PLANNING AMENDMENT

Application No. H21/0113/95

ERECTION OF GARAGE ONTO EXISTING HOUSE

RE: GARAGE ONTO "ROMANHURST", TYDD ST. MARY...
PLANNING REF: H21/0113/95 DATED 27/3/95
BUILDING CONTROL REF: B21/0066/95 DATED 23/2/95.

SIDE ELEVATION
REAR
6500 %
A
PROPOSED GARAGE
WIDEN DRIVEWAY
EXISTING ACCESS
PARKING AND TURNING
LAY BY
A1101
ROMANHURST

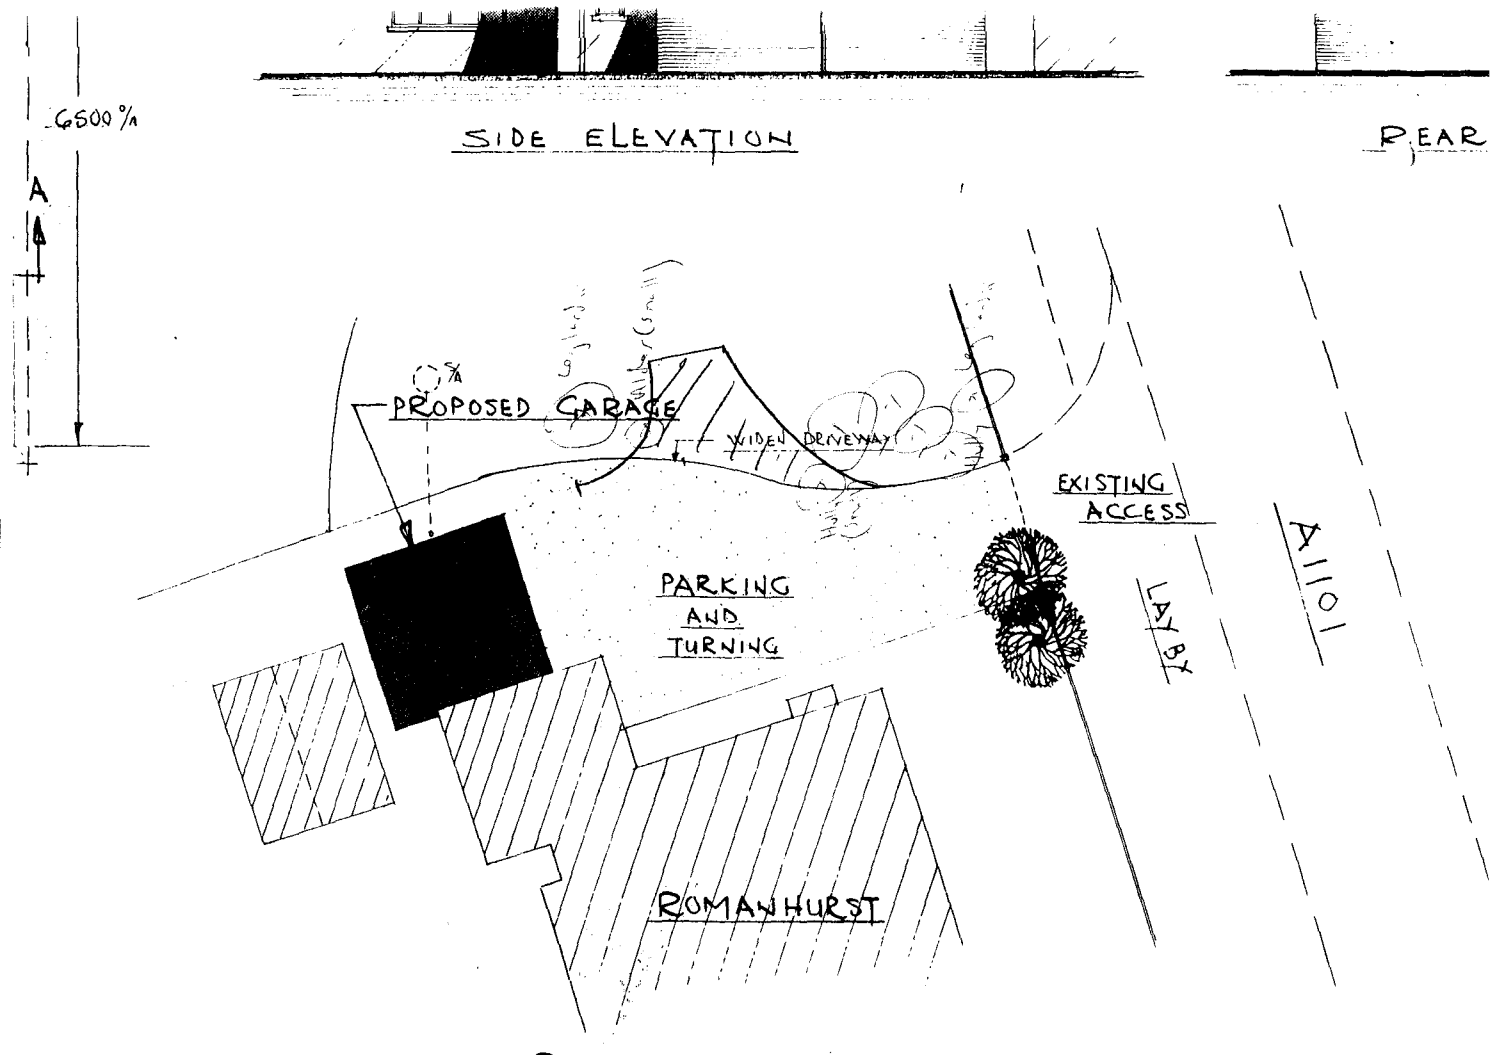
TURNING AREA INDICATED ON BLOCK PLAN AS REQUESTED BY PLANNING DEPT.

I refer to the above application, which has now been assessed by the County Highways Authority, who consider the proposed turning area to be inadequate.

This is because it is unacceptable to have vehicles reversing out onto the A1101. I therefore enclose a plan showing the provision of a satisfactory turning area. I will therefore be pleased to receive within the next 10 days four copies of a plan which include this area (or similar) within the driveway, so that I am in a position to proceed with the application.

6500%
A
SIDE ELEVATION
REAR
PROPOSED GARAGE
WIDEN DRIVEWAY
EXISTING ACCESS
PARKING AND TURNING
LAY BY
A1101
ROMANHURST

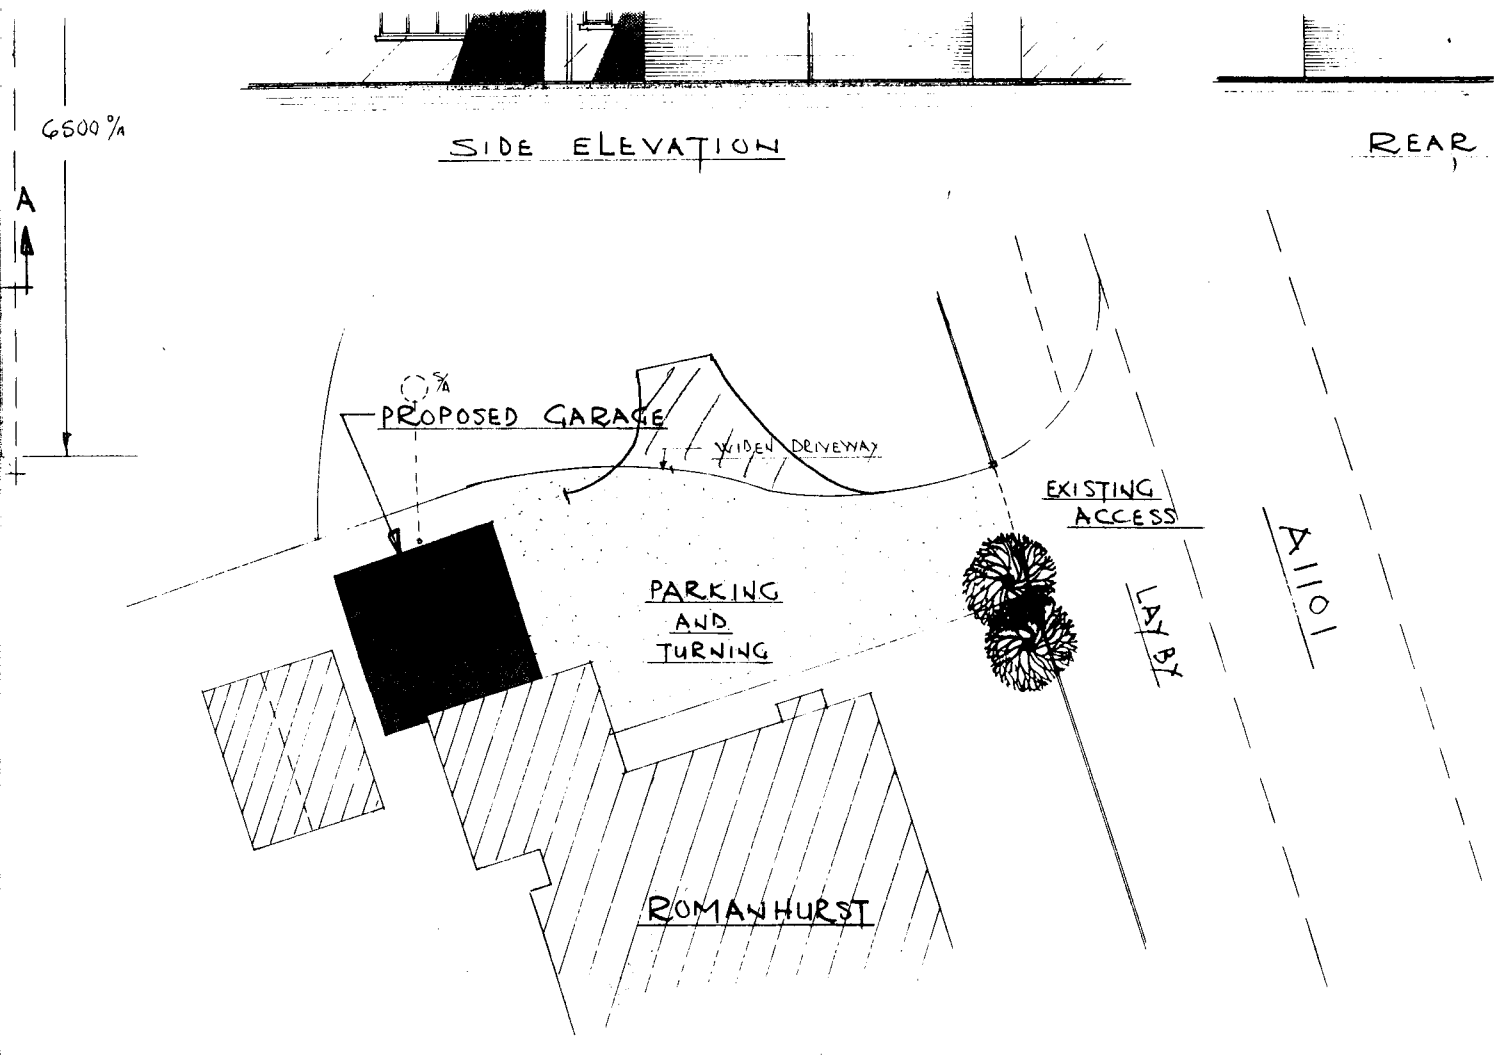
Width of doors to be altered.

The new occupiers of "Romanhurst" required the proposed garage to be 6600 wide with 2N° 2438 wide doors and not 6000 wide with 2N° 2135 wide doors.

AMENDMENT SUBMITTED: Width of doors to be altered (drawing no. 95/1/413 B)

The amended details submitted in respect of the above proposal have now been considered, and I am able to inform you that there are no objections to the amendment being implemented to the extent described above.
